Washington State Convention Center Addition Project

Design Review Board Design Recommendation Meeting 01
05-03-2016

PROPERTY ADDRESS	SITE A 1600 9th Avenue
SDCI PROJECT #	3020176

2 EDG 03 COMMENT
SUMMARY

OLIVE WAY ELEVATION

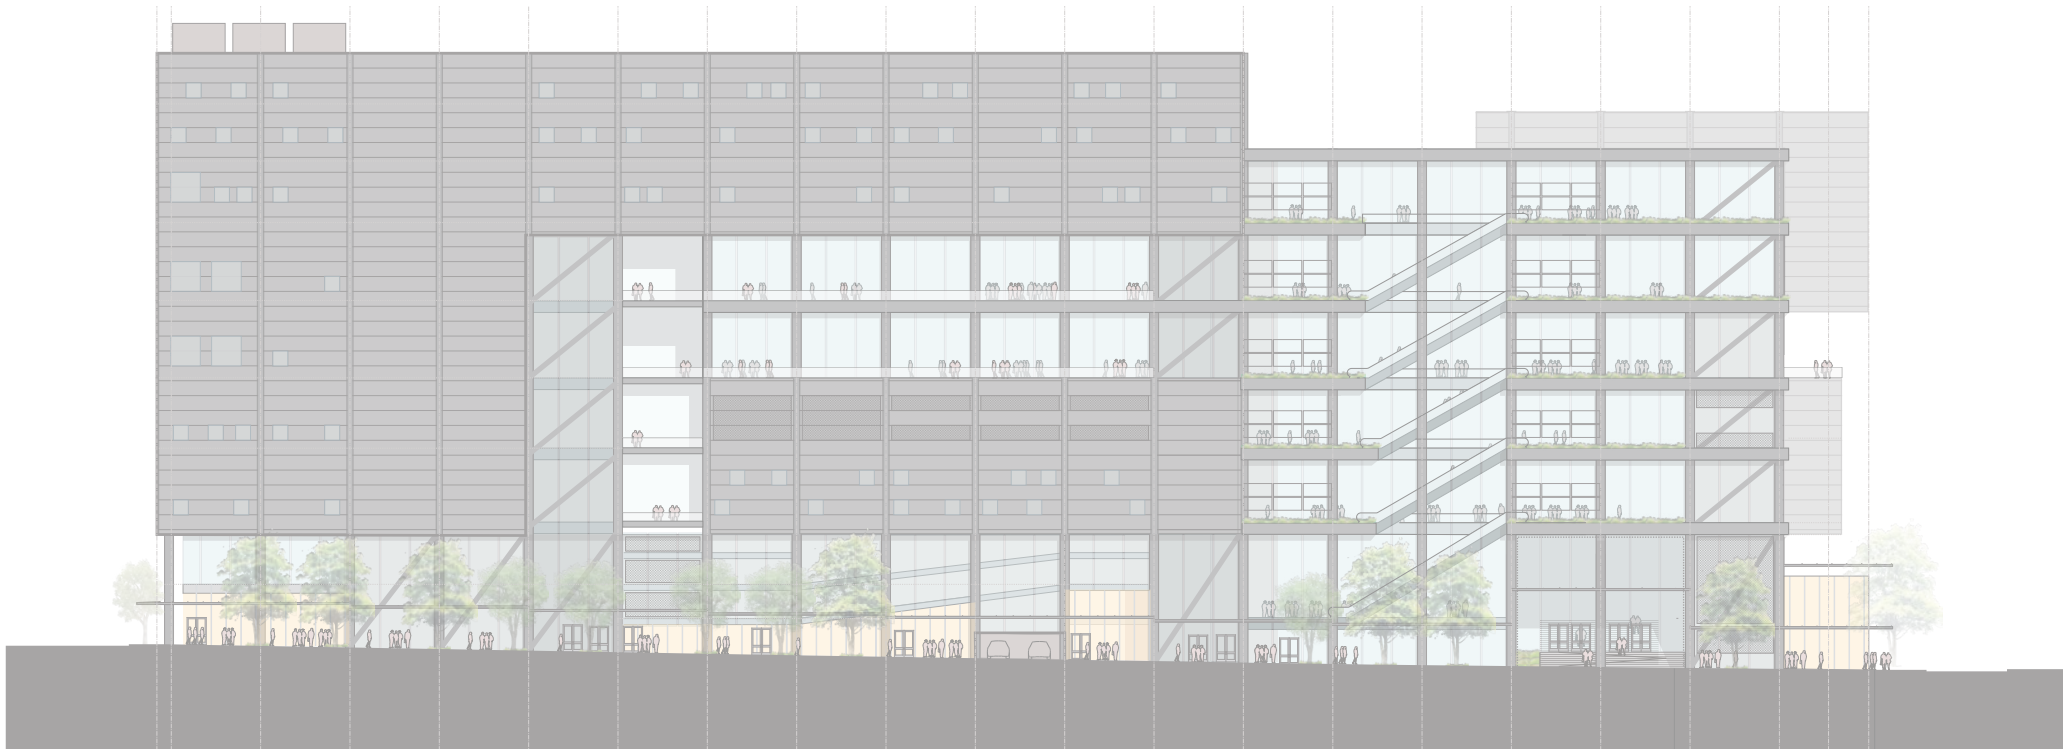
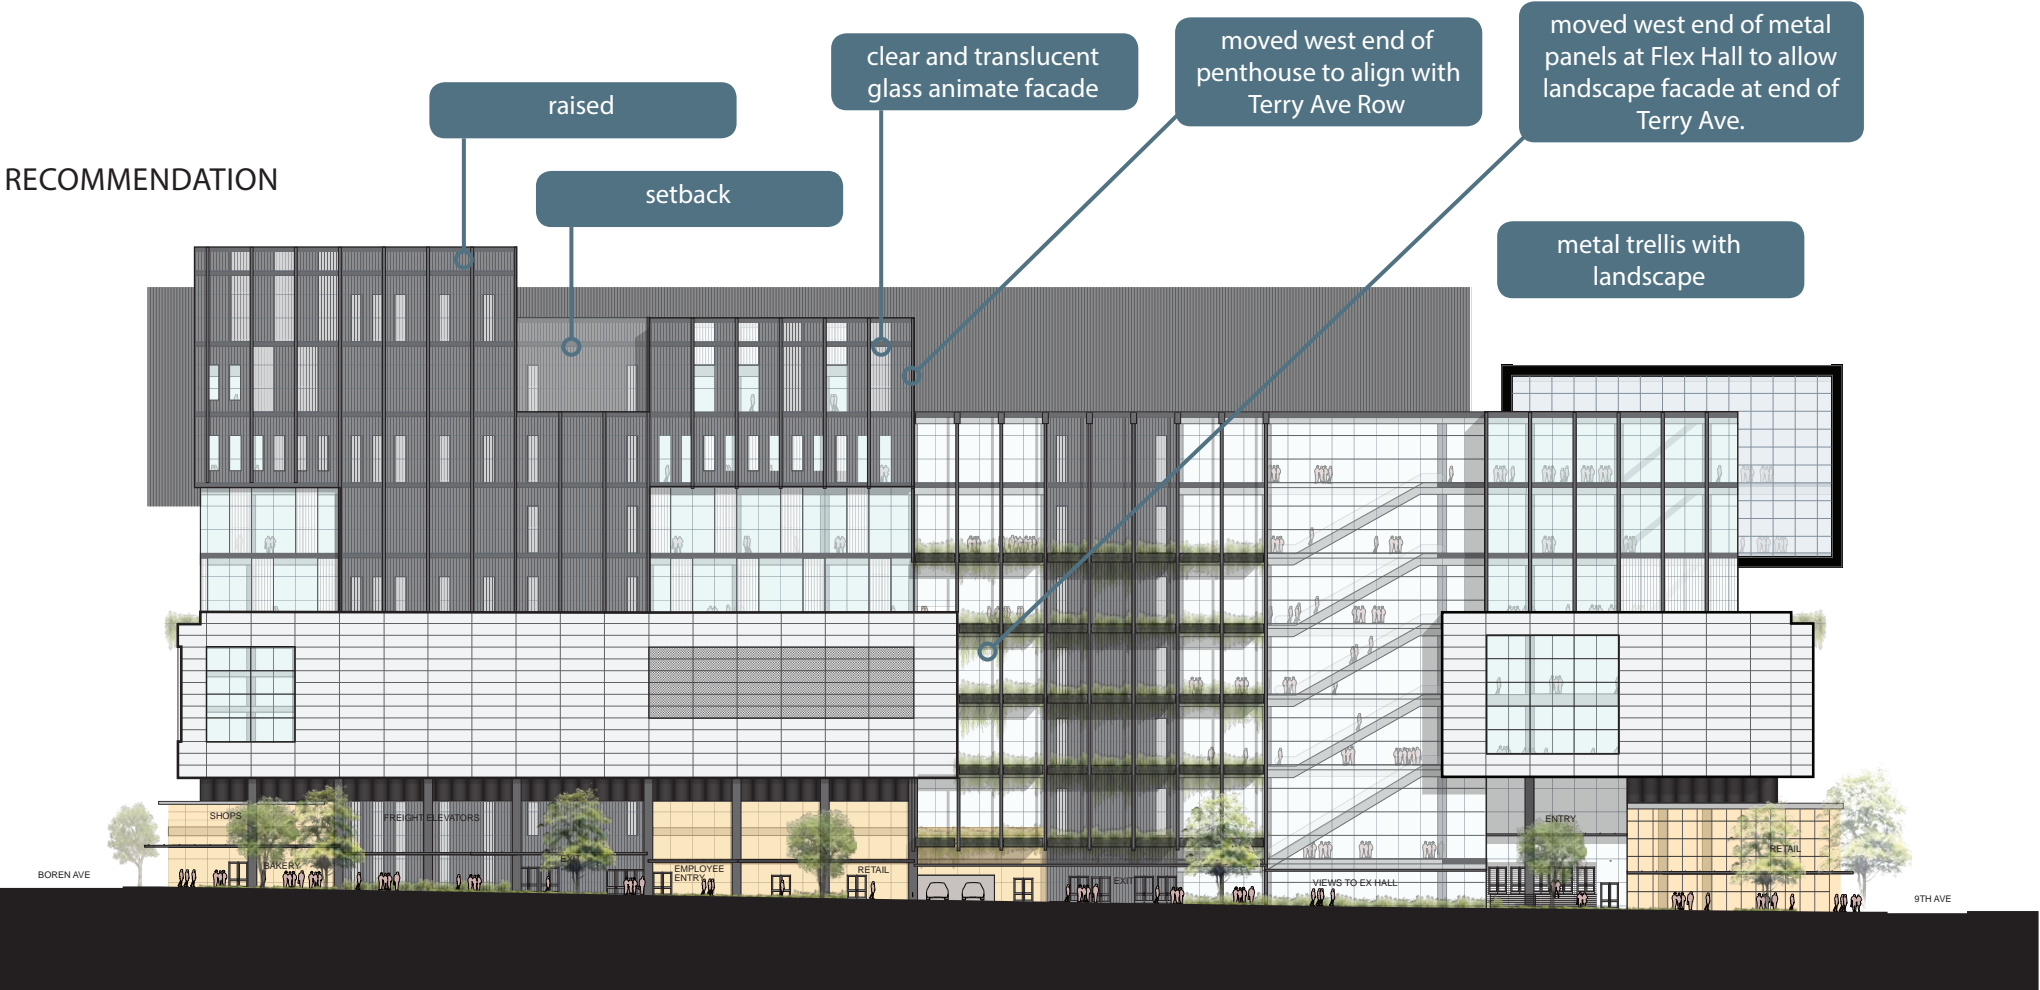
RECOMMENDATION 4 - FACADE/TERRY AVE. TERMINUS
Terry Avenue Perspectives: Additional views along Terry Avenue looking toward the Olive facade that is the Terry Green Street terminus, developing an intentional and scaled elevation response to that terminus condition, and showing the pedestrian edges of Terry Avenue and the adjacent building ground floors in detail. Diminish the loading doors on block B and wrap the presence of the Olive lobby around the southeast corner.

DEPARTURE COMMENT - MODULATION
The Board indicated receptivity for the reduced modulation depth of 6 feet, especially since it pertains to about one third of the facade above 85 ft, but was concerned the east parapet was three times longer than code allows. The Board recommended a complete and legible break in parapet and the massing at about the 150 ft point from Boren, which appears to correspond with a stack of exterior balconies on levels 3–6 (pg 44) and which the Board encouraged continuing up to the parapet. (A2; B2; B4)

RESPONSE - The Olive Way elevation has been revised to create a more expressively scaled facade with the surrounding context. The intersection of Terry Avenue at the mid-block is highlighted though a vertical setback in the building mass and an overlay of finer scaled garden structure. This provides depth, texture, and richness appropriate to receive the Green Street character, transitioning west to link back to 9th Avenue. The Co-Development towers that defines Terry Avenue on the east and west will be presented at a subsequent meeting.

RESPONSE - The parapet along Olive Way has been revised to provide more variety of articulation, vertically and horizontally, breaking the overall length into shorter stepped segments that respond to the urban context. The resulting composition expresses the collage of program elements more clearly on the Olive Way facade, breaking down the mass into smaller legible pieces.
